Submission on an Application for Resource Consent By M S and V J Lambert (SUB-2015-78 & LUC-2015-443)

SUBMISSION ON AN APPLICATION FOR RESOURCE CONSENTS UNDER SECTION 95 B – SUBDIVISON AND LANDUSE

RE: Resource Consent Submission (SUB-2015-78 and LUC-2015-443)

Picture 1: 20160529_193352 Taken at: 7:33pm On: 29/05/2016 Picture 2: 20160529_193444 Taken at: 7:34pm On: 29/05/2016 Picture 3: 20160529_201050 Taken at: 8:10pm On: 29/05/2016

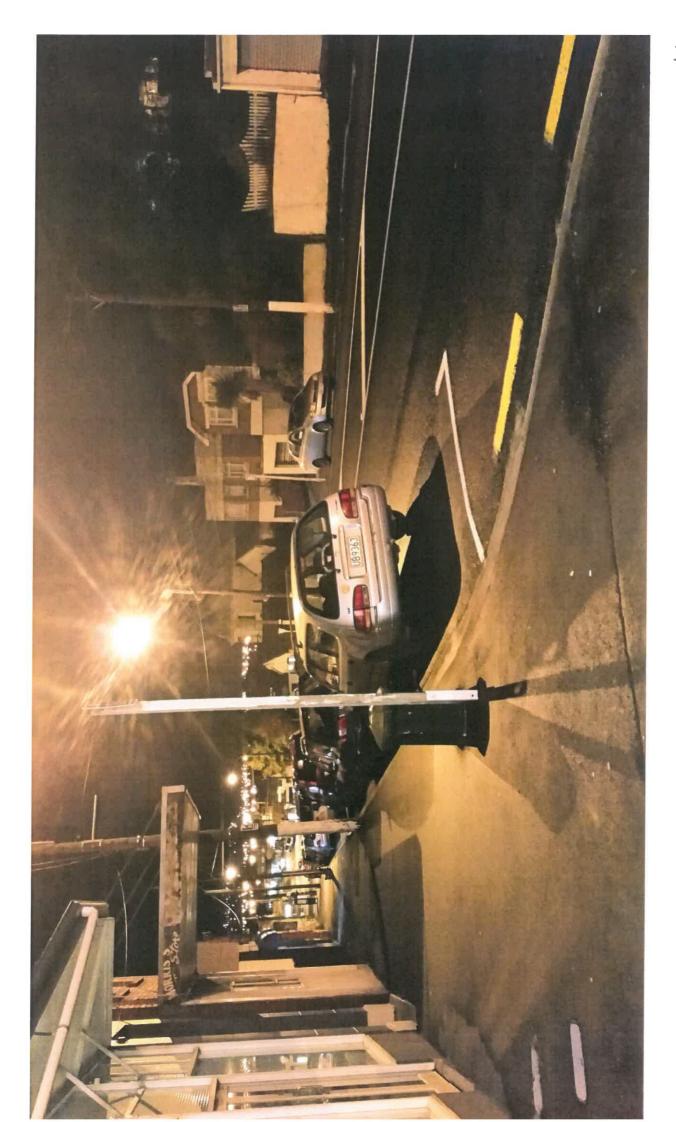
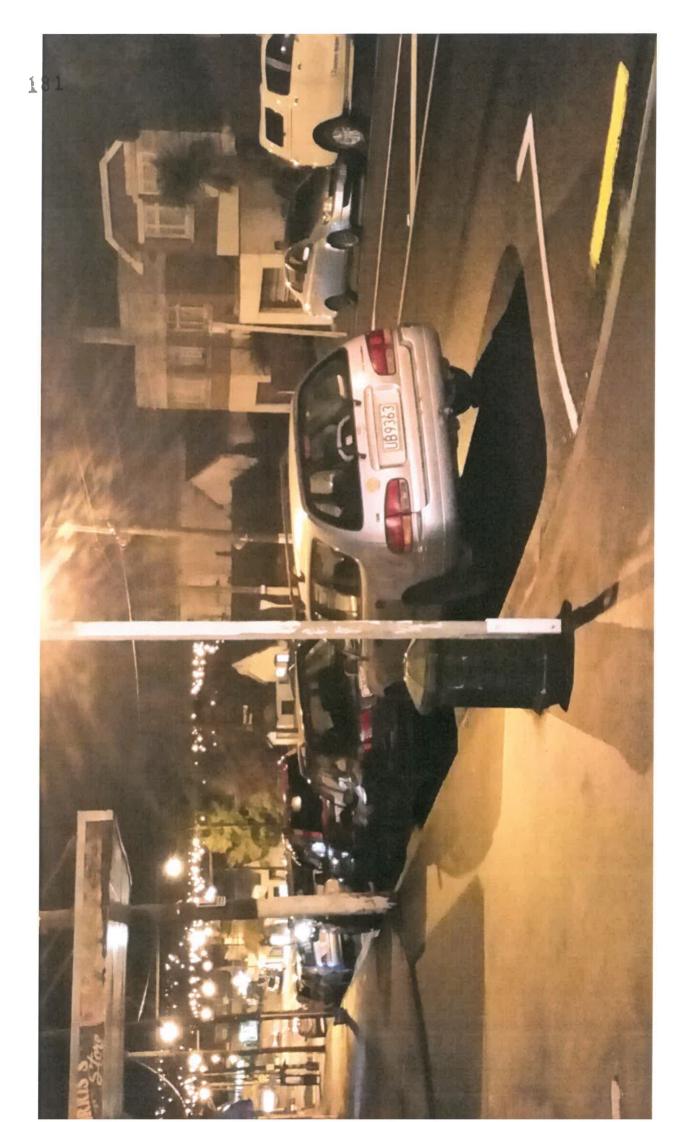
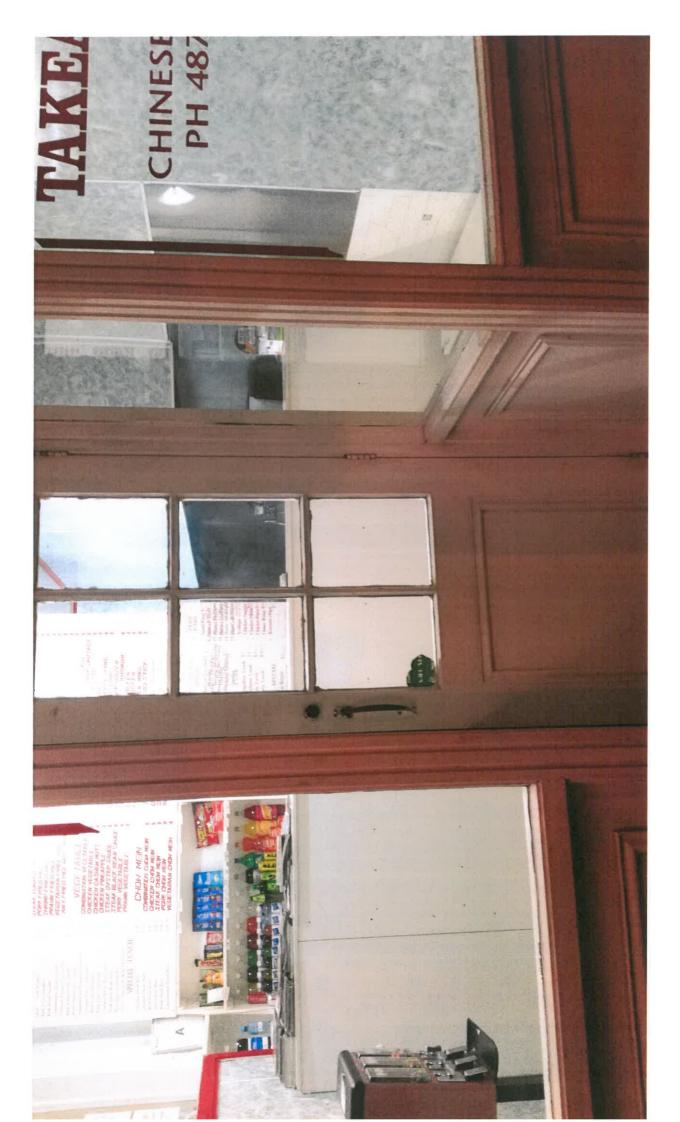
To backup our opposition to the resource application proposal at 380 South Rd, (submitted on the 27th of May), we have attached three images taken on Sunday evening, 29th May 2016. The first two images show our empty business yet the street parking is full, with vehicles also parked in the ten minute zones. The third photo was taken roughly forty minutes later. Vehicles have not moved. Hopefully this shows some of the parking issues already happening on South Rd.
